Project	IEEE 802.16 Broadband Wireless Access Working Group < http://ieee802.org/16 >	
Title	Definition of H-ARQ Compact DL/UL MAP IE extension type for Band AMC, OFDMA PHY mode	
Date Submitted	2004-08-17	
Source(s)	Won-Hyoung Park, Sangboh Yun, Sung Hyun Cho, Yungsoo Kim Samsung AIT	whpark@samsung.com
	Yong Chang, Geunhwi Lim, Hong Sung Chang, JungWon Kim, TaeWon Kim Samsung Electronics Co. Ltd.	yongchang@samsung.com
Re:		
Abstract	Definition of H-ARQ Compact DL/UL_MAP IE extension type for Band AMC, OFDMA PHY mode	
Purpose	Adoption of proposed changes into P802.16e/D4	
Notice	This document has been prepared to assist IEEE 802.16. It is offered as a basis for discussion and is not binding on the contributing individual(s) or organization(s). The material in this document is subject to change in form and content after further study. The contributor(s) reserve(s) the right to add, amend or withdraw material contained herein.

1 Motivation and explanation of changes

2 Proposed changes

Figure aaa Examples of subchannel allocation modes of Compact DL/UL-MAP IE extension for Band AMC

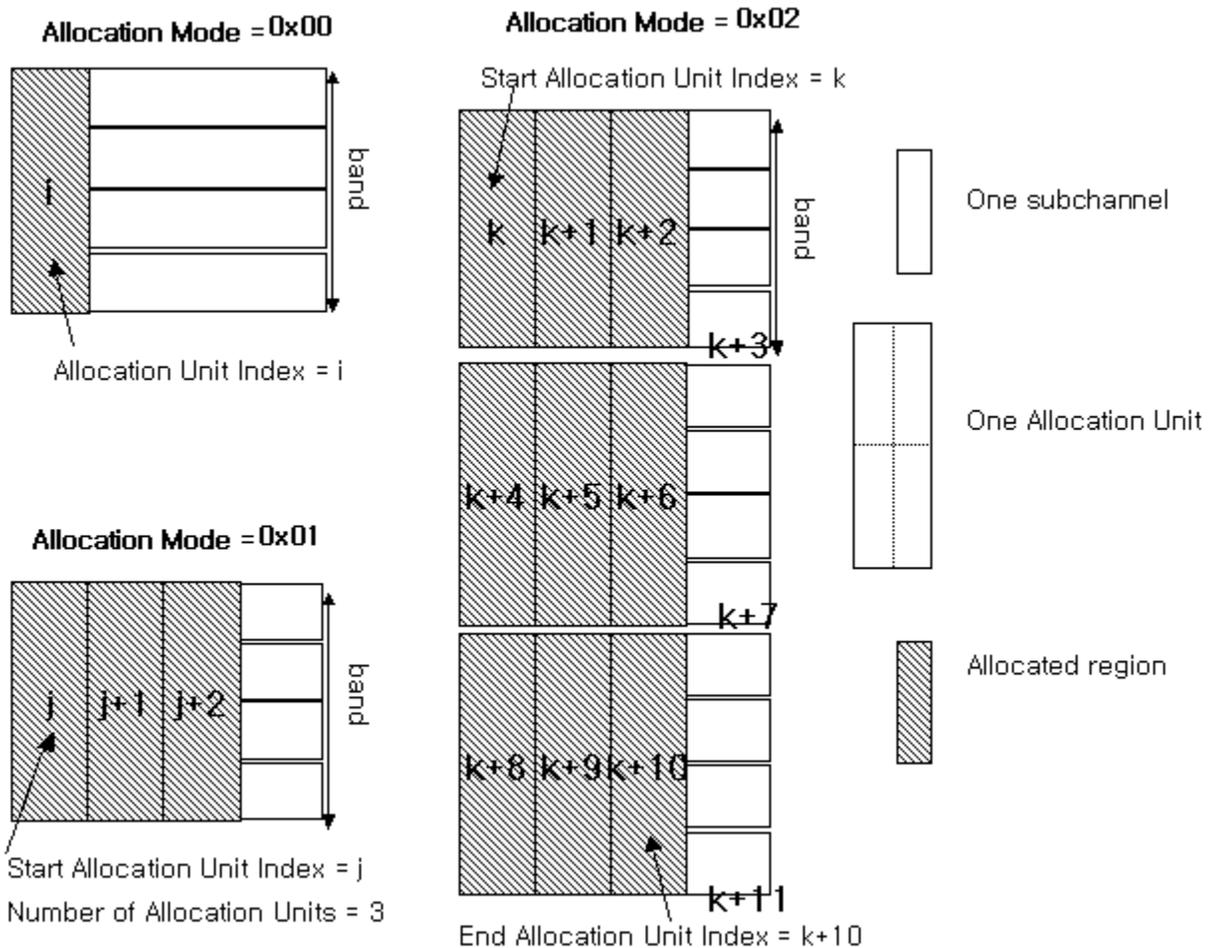
The value is set to 0x02 when resources of a rectangular area are allocated. The following Start Allocation Unit Index and End Allocation Unit Index fields indicate the diagonal starting position and ending position of the allocated rectangular area respectively.

The value is set to 0x03 when the same resources allocated to this RCID last time are allocated again. When this mode is used, both Same AUT and Same AM values are set to 1. To support this allocation mode, MS and BS must store the position of the resources allocated last time during the connection is maintained.

The allocation mode variant is shown in Figure aaa.
